SDB IR300 02 Insulation too low

The IR 300 repeater has too low insulation between -24VDC and the ground.

Fig. 1

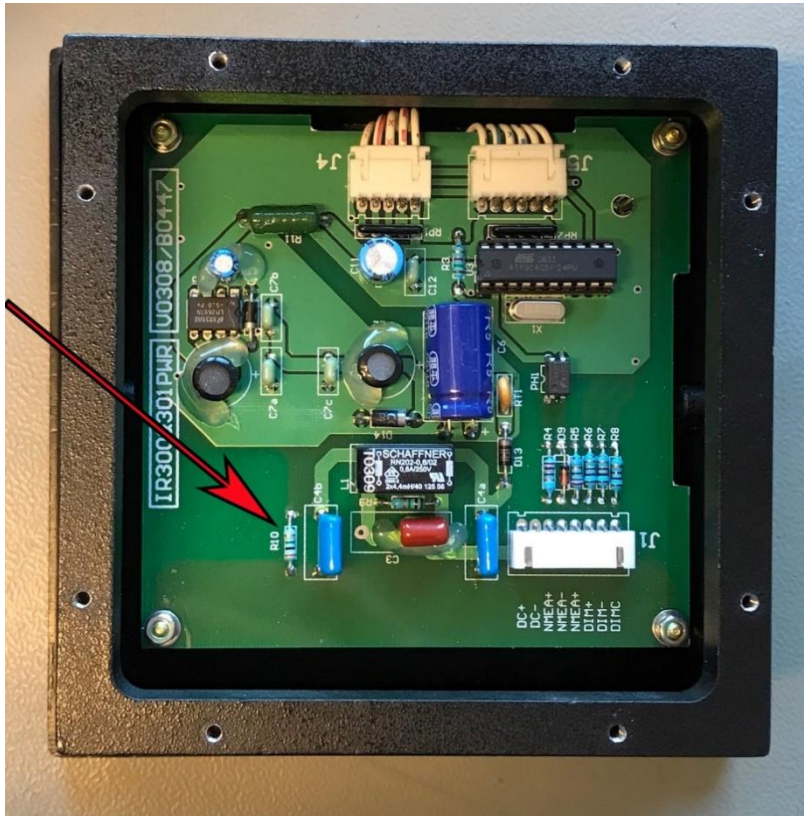
This is caused by resistor R10 and applies to HW version < 1.8

The low insulation problem can be solved by cutting away resistor R10.

- 1) Loosen the 8 screws/washers holding the backplate of the IR300
- 2) Take care when lifting the backplate and observe J1
- 3) Locate **R10** on the IR300&301PWR PCB as shown on Fig. 1 and cut away
- 4) Assemble back in reversed order making sure J1 is in place
